To: AUTHORISED DEALERS/DISTRIBUTORS
 N.Z. APPROVED INSTALLERS
 H.O., REG'L & AUST. MANAGERS
 APPLIC. NOTICE GENERAL LIST

Issue No.: 01/15
 Date: 6th March 2015
 From: T King

Subject: CONNECTING ALTERNATIVE THERMOSTATS (NON-COMMUNICATING CONTACT SWITCHING TYPE)
 Units: OPA 116-201 c/w UC7 and 24V relays removed and ISD/OSA 116-224 with IUC/UC8

Connecting a thermostat or other controller to the UC7 using 12V DC control signals.

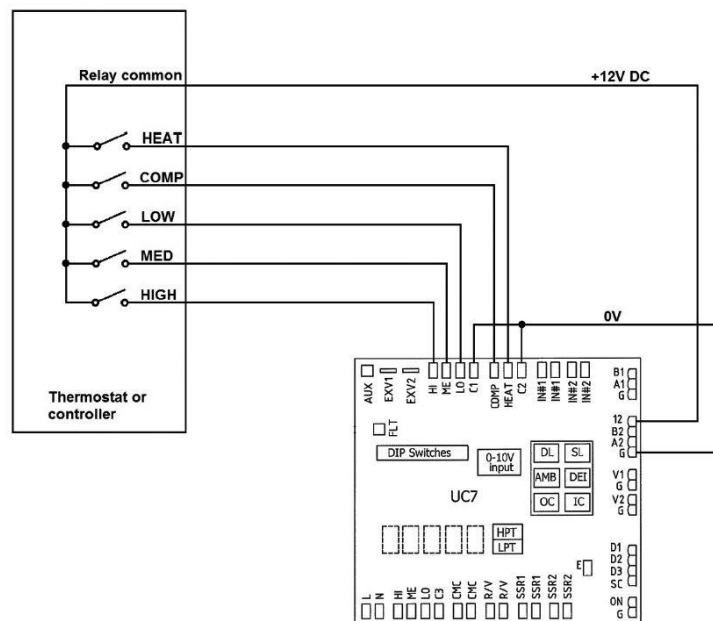
Recently it was decided to remove the 24 volt control relays from the small over/under OPA range of units containing UC7 unit controllers as they were seemingly superfluous to requirements.

As a result it may have become a little confusing when making the electrical connections and using a conventional thermostat.

The connections that were previously made to a terminal block labelled HOT 24V, COM 24V, COMP 24V, HEAT 24V, LOW IN 24V, MED IN 24V and HIGH IN 24V will now be made directly to the UC7 unit controller PC board.

The wiring method is shown below:

Connecting a thermostat or other controller to the UC8 using 12V DC control signals.

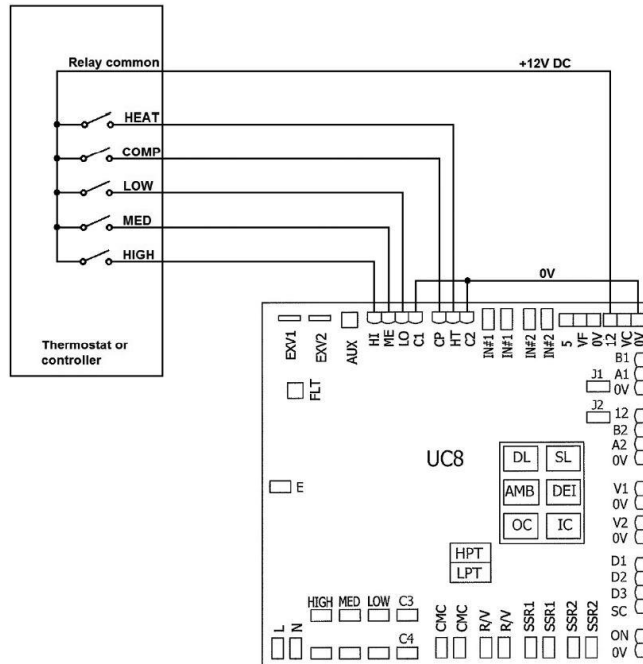
The same wiring detail will also apply to the new 2015 range of OSA split system units utilizing the UC8 Unit Controller, however, the terminal shown above labelled as 'G' is labelled '0V' on the UC8 (refer diagram overleaf).

Connecting a thermostat or other controller to the IUC.

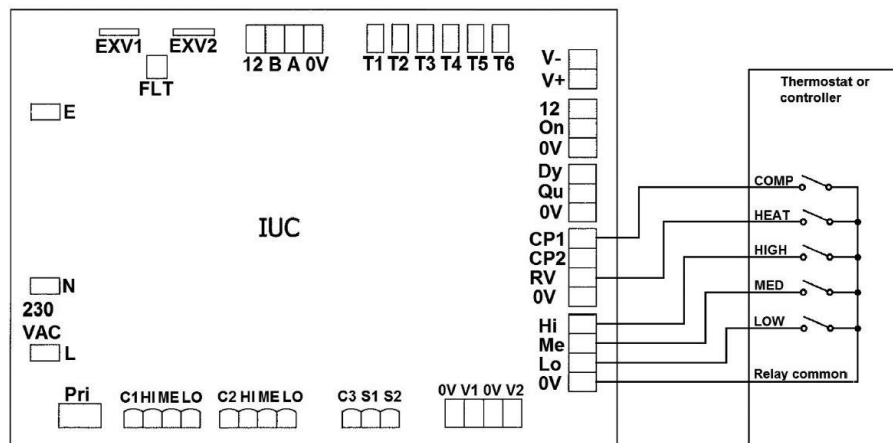
The new range of ISD/OSA units will also have the option of an alternative thermostat being connected to the IUC (Indoor Unit Controller) on the indoor unit instead of the outdoor unit. The wiring is similar but the layout is somewhat different and is shown below:

Connection to 0V on this diagram is not an error.

NOTE: DO NOT try to connect an alternative thermostat to both the IUC on the indoor unit and the UC8 on the outdoor unit. It is one or the other not both.
